## PLANNING BOARD

To: Chair Mazer & Members of the Planning Board  
From: Charles Tetelman  
Date: June 23, 2023  
Re: 70 Thames Street / 100 Fore Street  
Project ID: PL-002437-2023  
CBL: 019 A008001, 019 A002001  
Meeting Date: June 27, 2023

144 Fore St. OZ, LLC has submitted a Major Site Plan application to facilitate the construction of a 72,857 square foot, three-story mixed-use building at 70 Thames Street and 144 Fore Street. The building includes corporate office space for WEX, a third-floor restaurant, and first-floor retail space. Additionally, the application includes plaza and park spaces containing five, 256 square foot buildings intended as business incubator spaces. This application is being referred to the Planning Board for compliance with the City of Portland's Land Use Code Site Plan Standards, section 14.6.

1 | SOUTH ELEVATION  
3/32" = 1'-0"

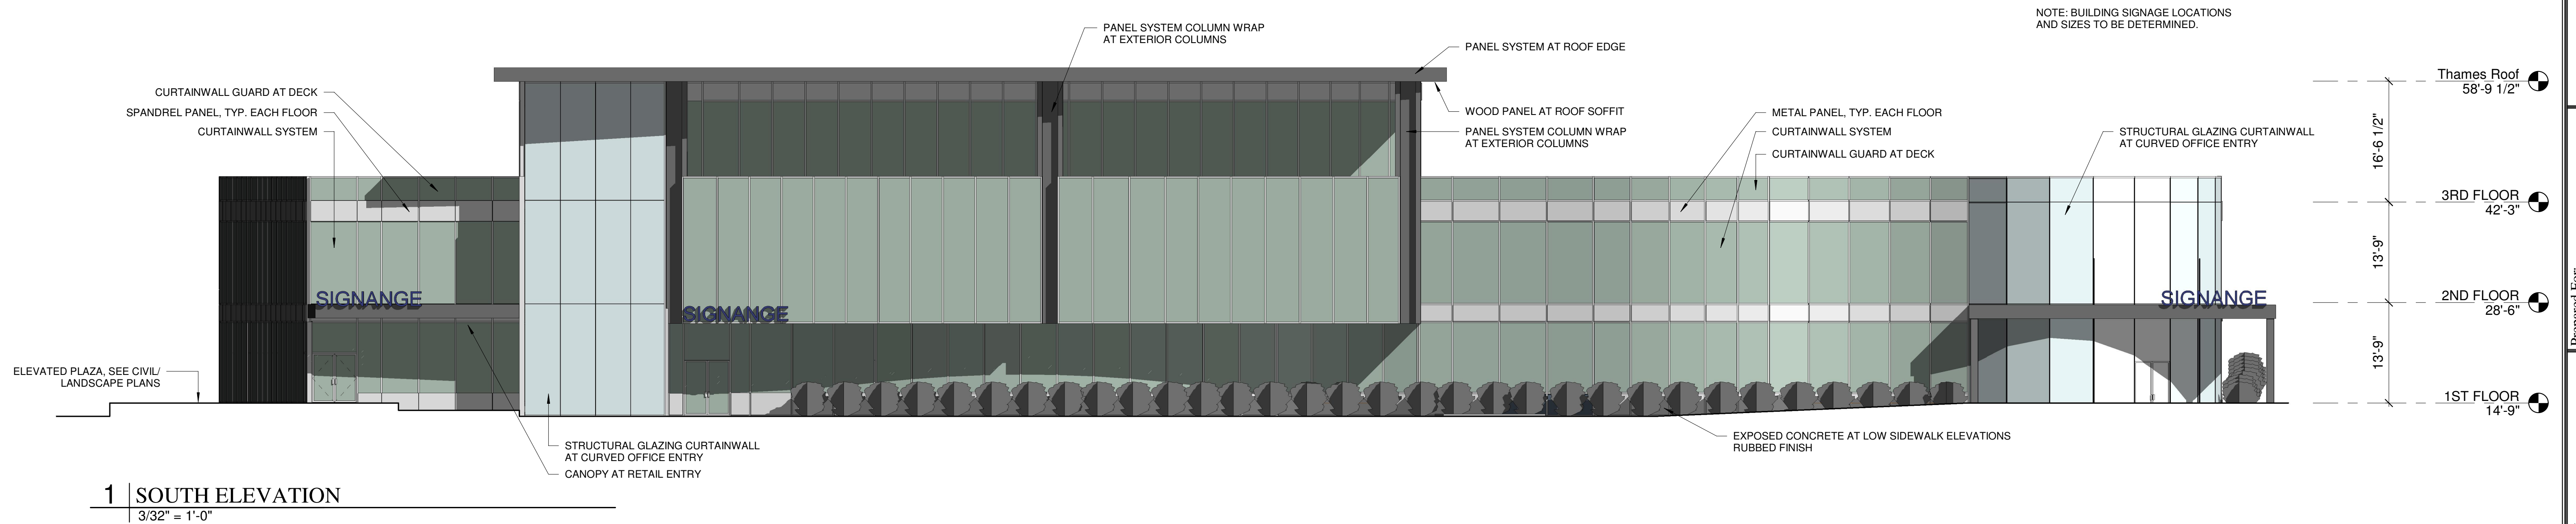
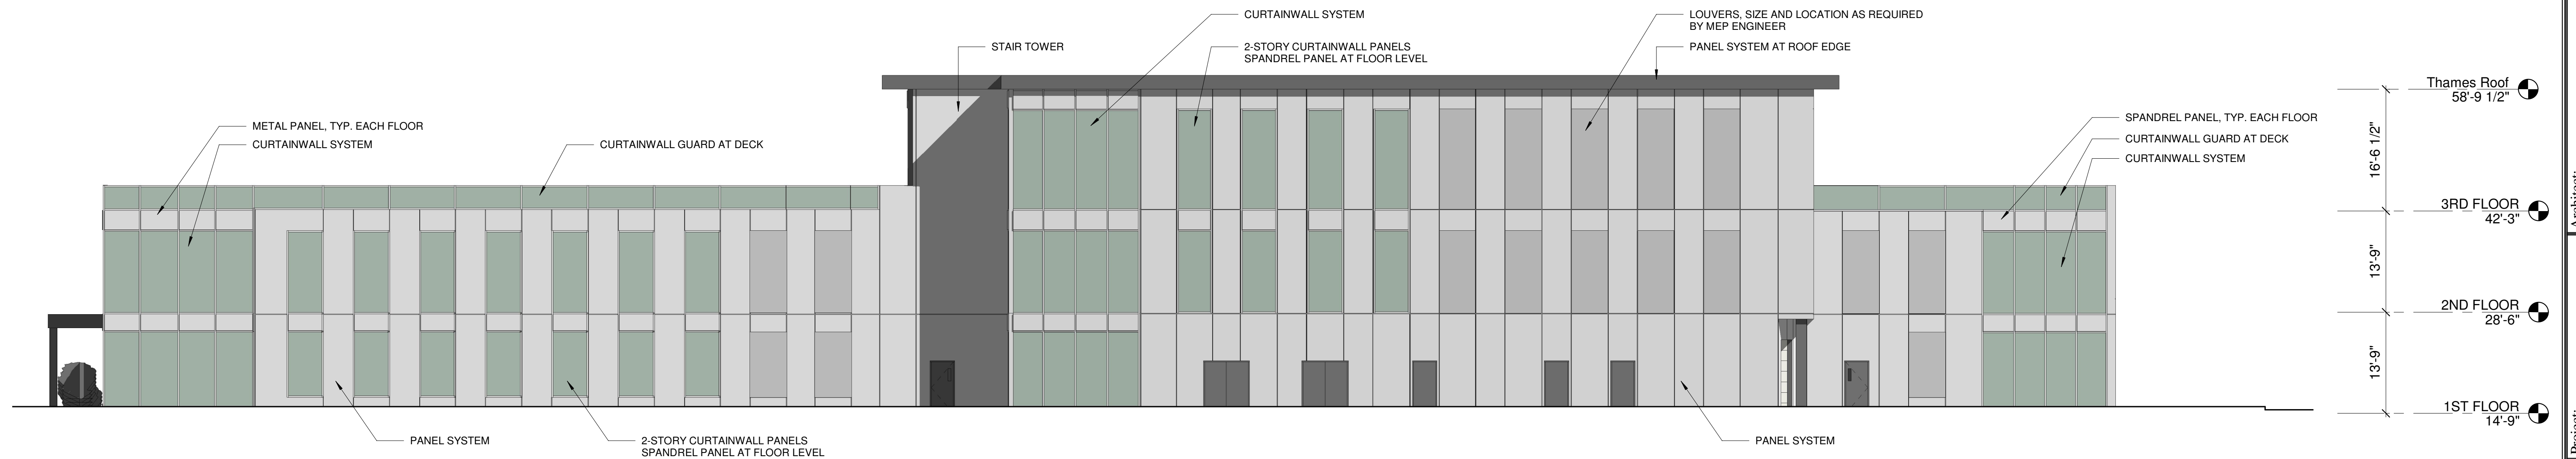
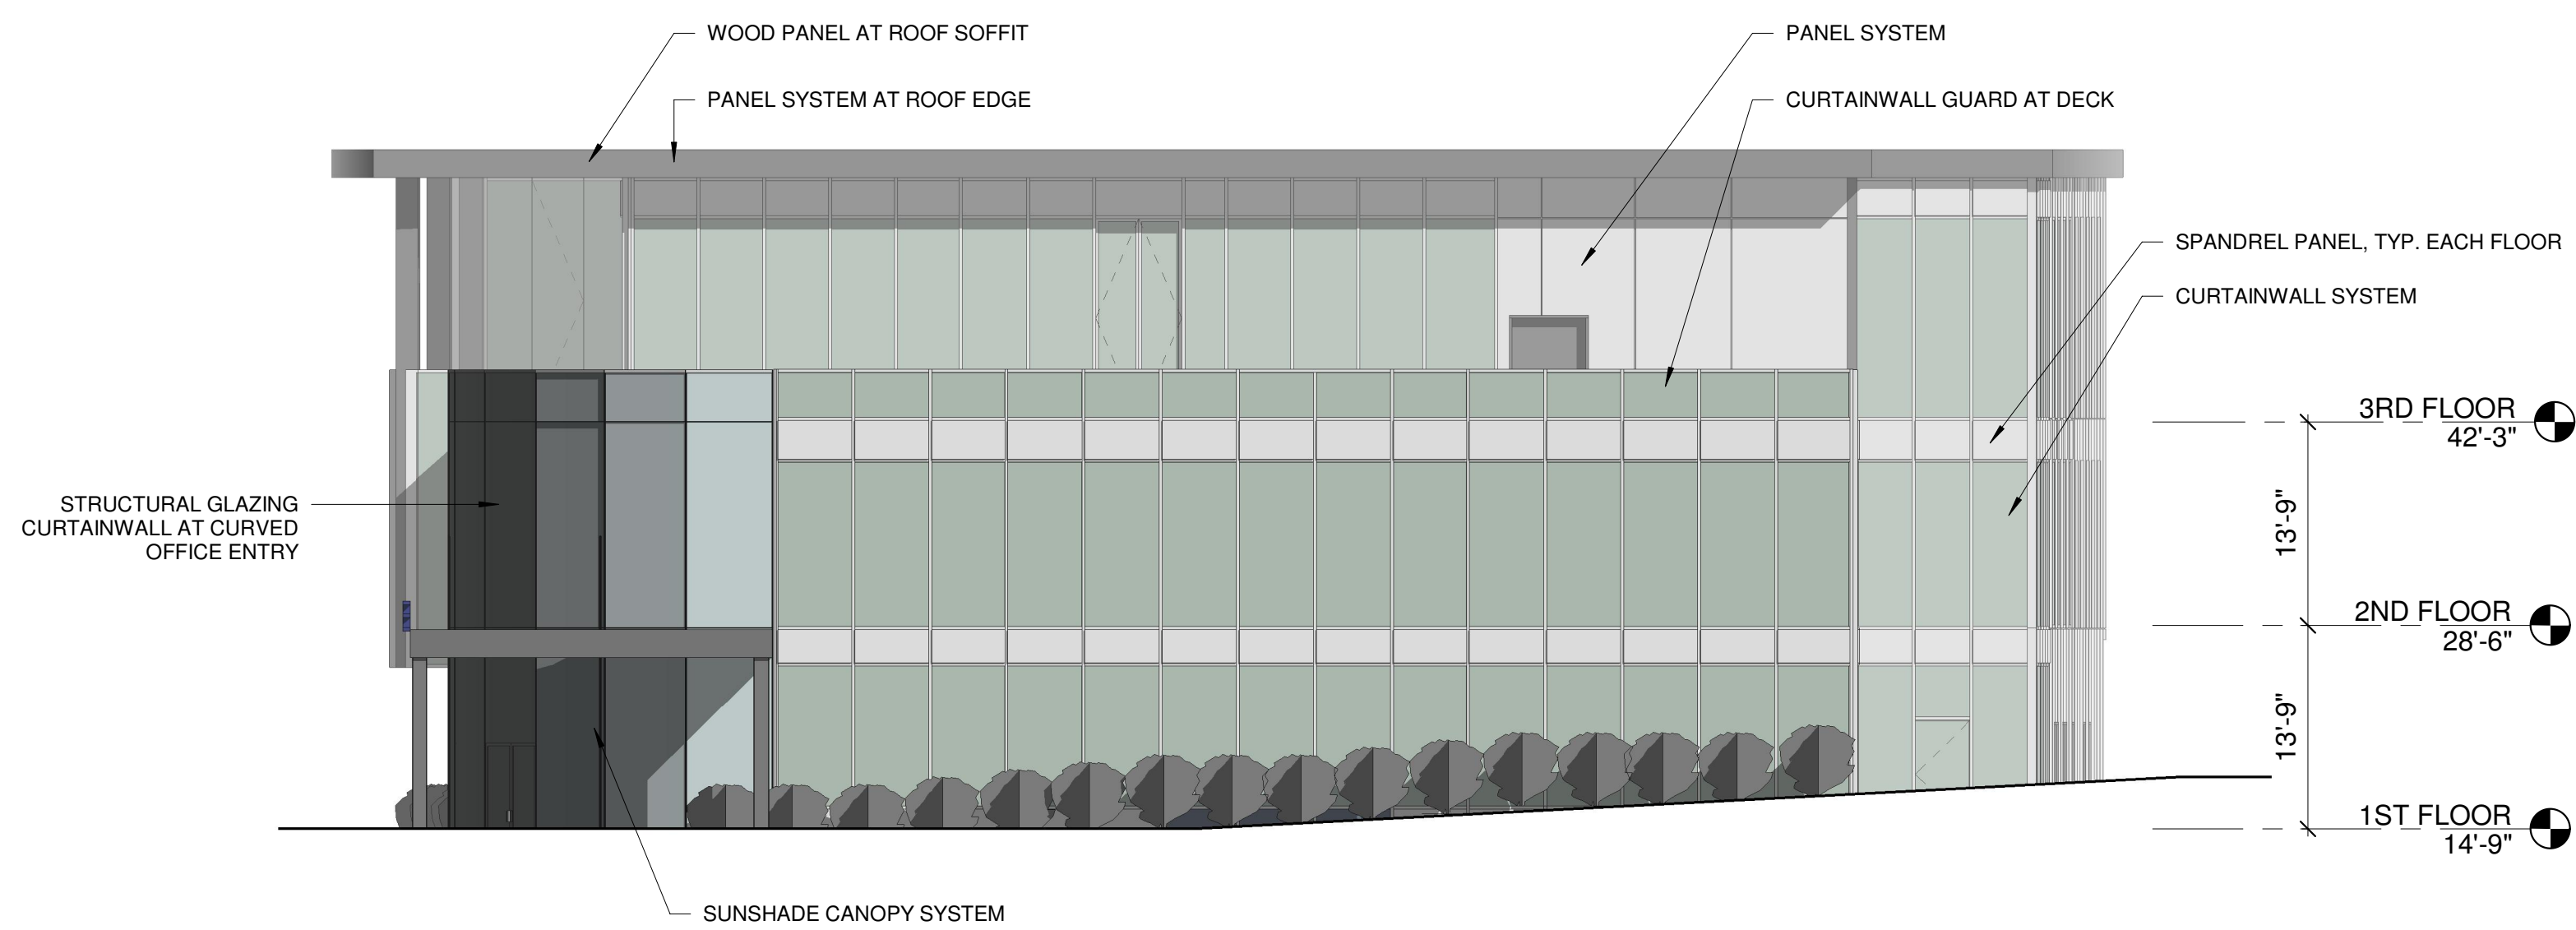
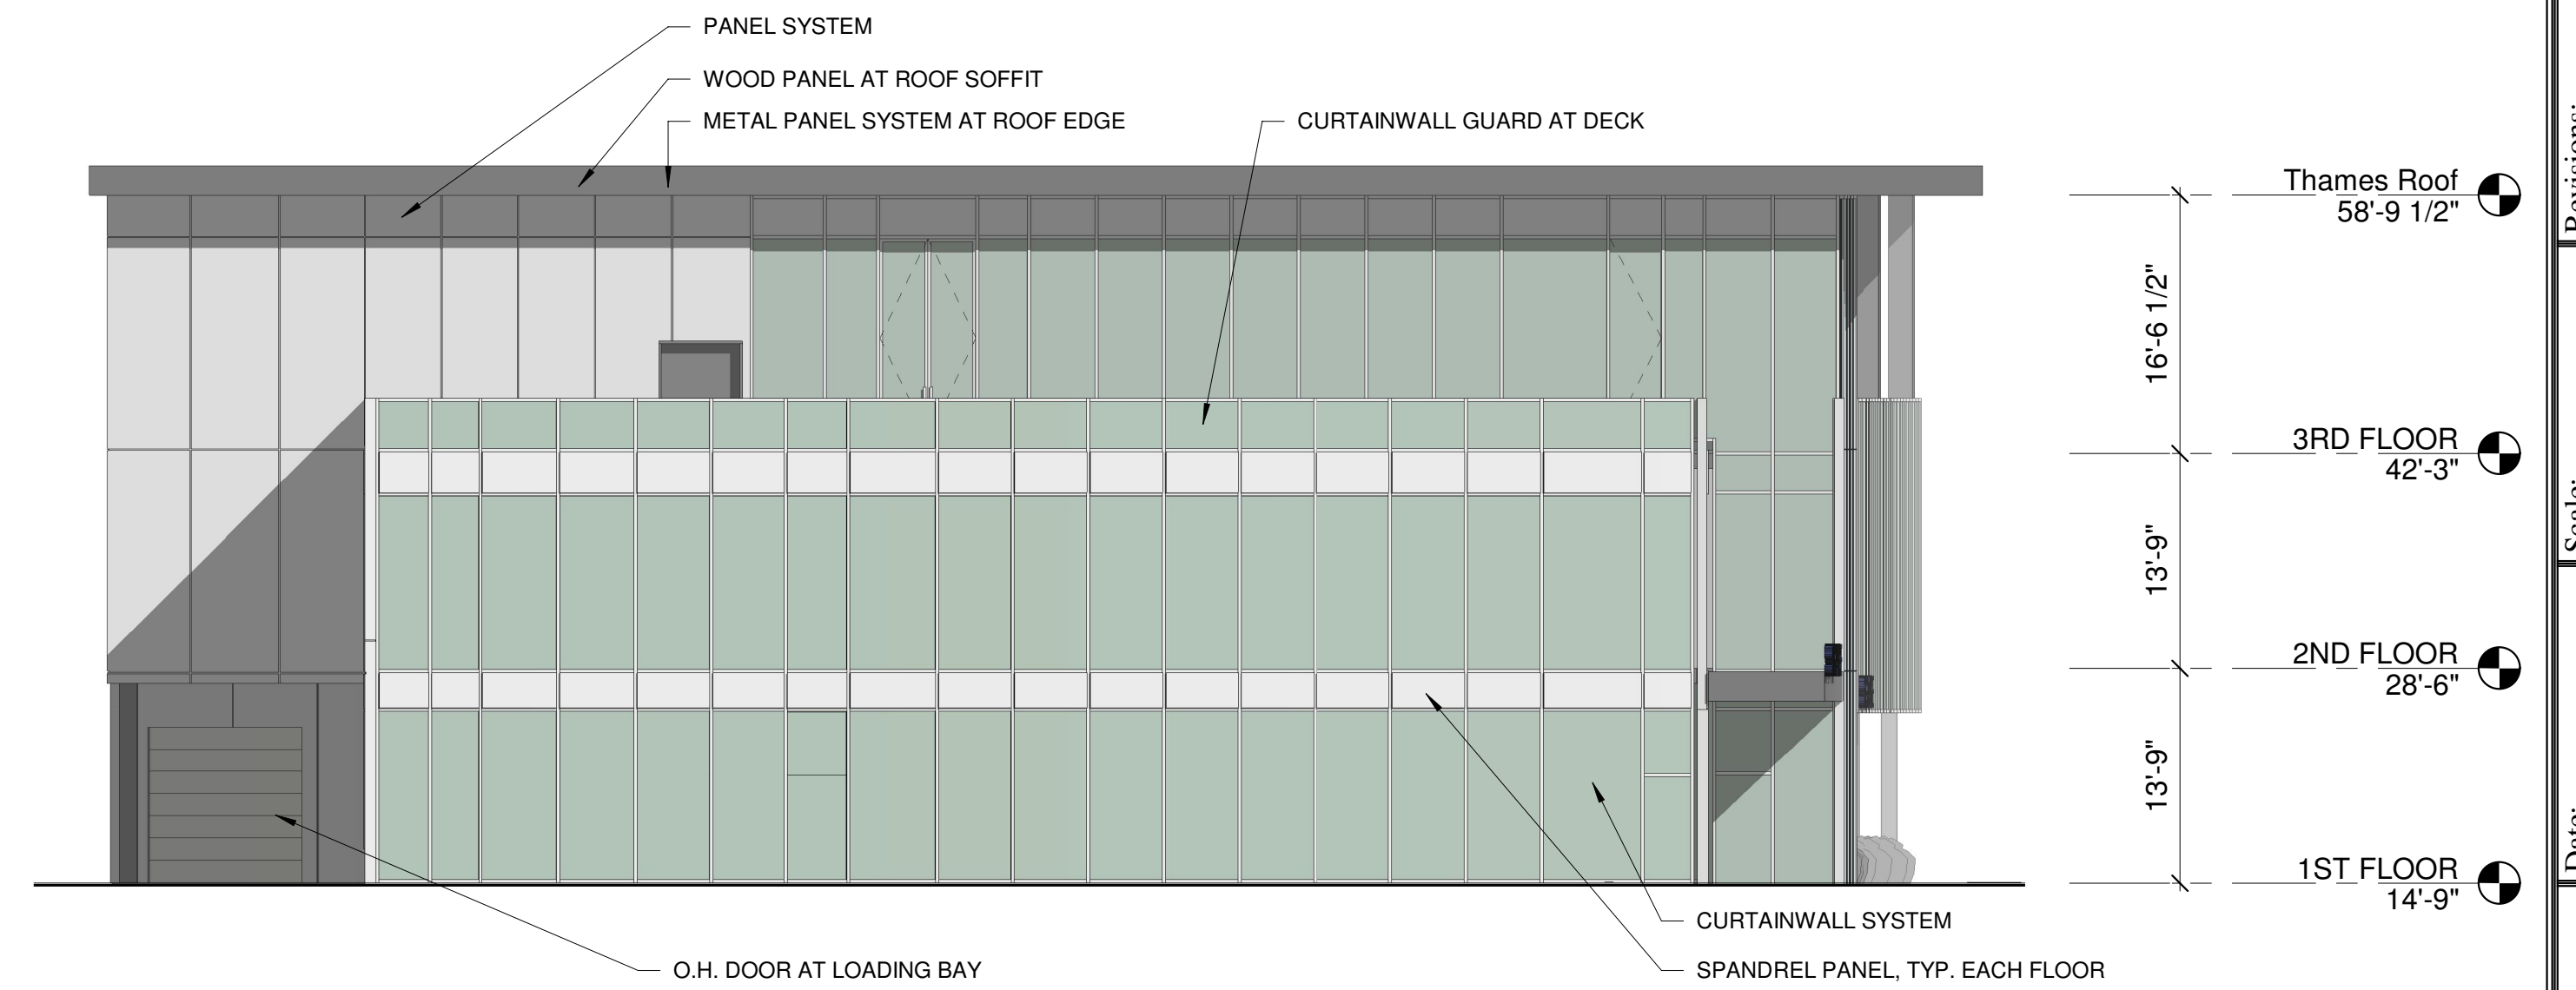
- Zoning Analysis Table notes the required maximum height is 65 ft. Looking at the B-6 Zone Building Height Overlay Map, the proposed site is in the 45 ft. maximum height area. The elevations (A2.01) need to show the height from the average grade to the roof beam and also need to show how average grade is determined.

3. *Zoning Analysis Table notes the required maximum height is 65 ft. Looking at the B-6 Zone Building Height Overlay Map, the proposed site is in the 45 ft. maximum height area. The elevations (A2.01) need to show the height from the average grade to the roof beam and also need to show how average grade is determined.*
